City of Saco, ME
Planning Board Agenda
Tuesday, March 30, 2021 – 5:30PM
Regular Meeting & Public Hearings
Location: Remote via [Zoom.us](https://zoom.us)
All votes to be taken by roll call.

City of Saco, ME
Planning Board Meeting Minutes
Tuesday, March 2, 2021 – 6:00PM
Regular Meeting & Public Hearings
Location: Remote via Zoom.us
All votes taken by roll call.

PLOT PLAN, #66 OLD ORCHARD ROAD, SACO, MAINE
 MADE FOR MANN ENTERPRISE, INC. APRIL 13, 2020
 BY OWEN HASKELL, INC.

Drawing No.
C-5.2

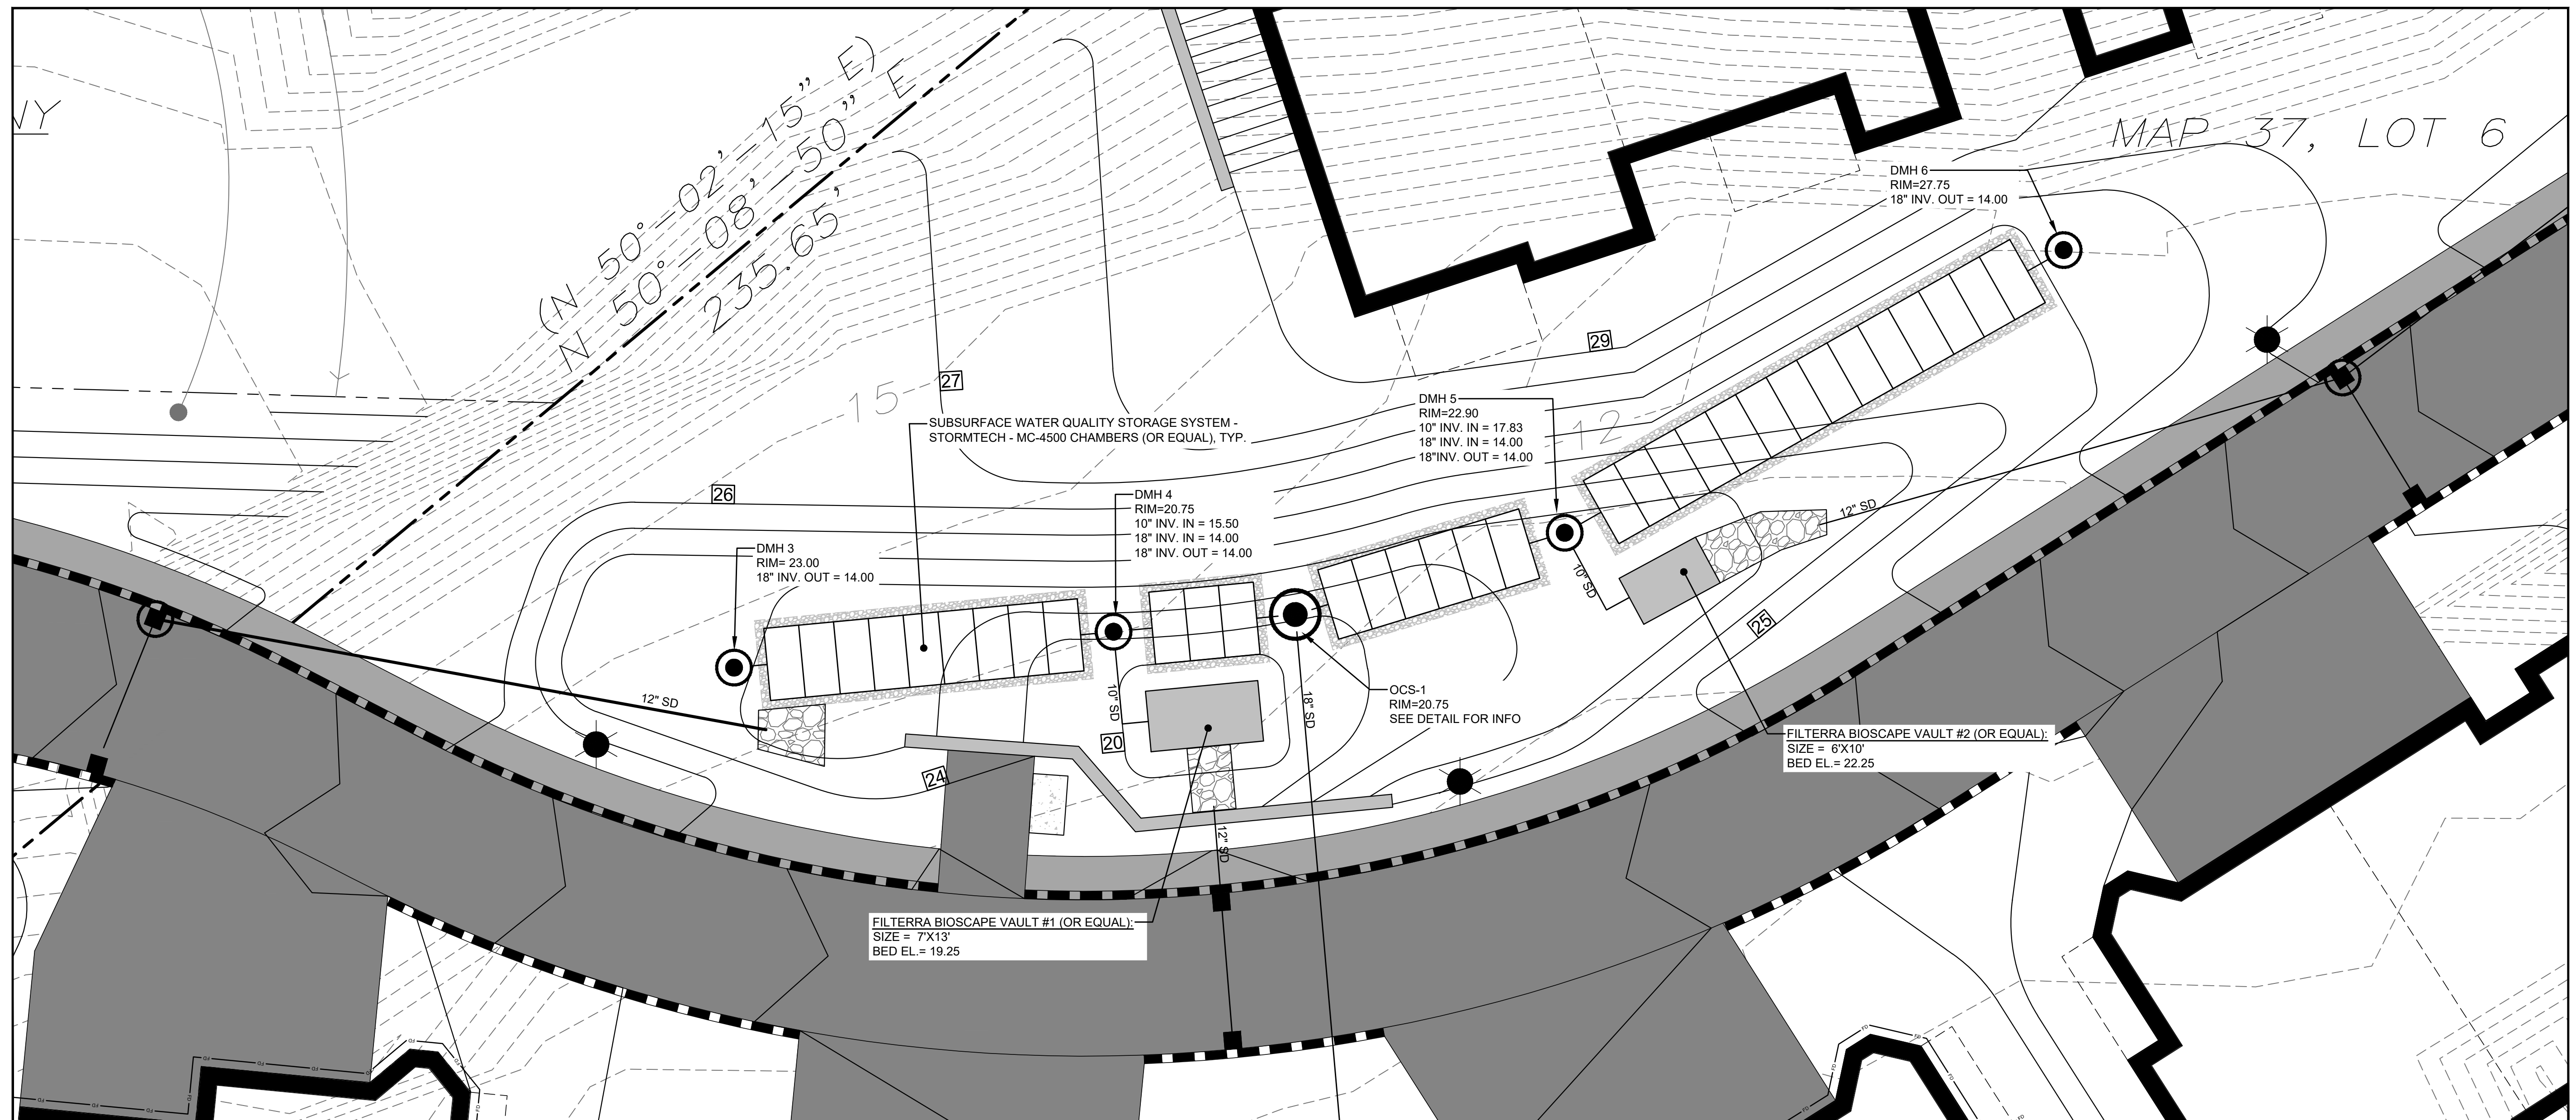
3. *Sheet C-7.4:*
 - a. *Detail G for the Bioretention Filter references, “See landscape plan for specific basin plantings.” Provide planting information for each of the biofilters that calls out species, quantities, and condition.*

Response: See the updated C-5.2 plan for additional information on specific basin plantings.
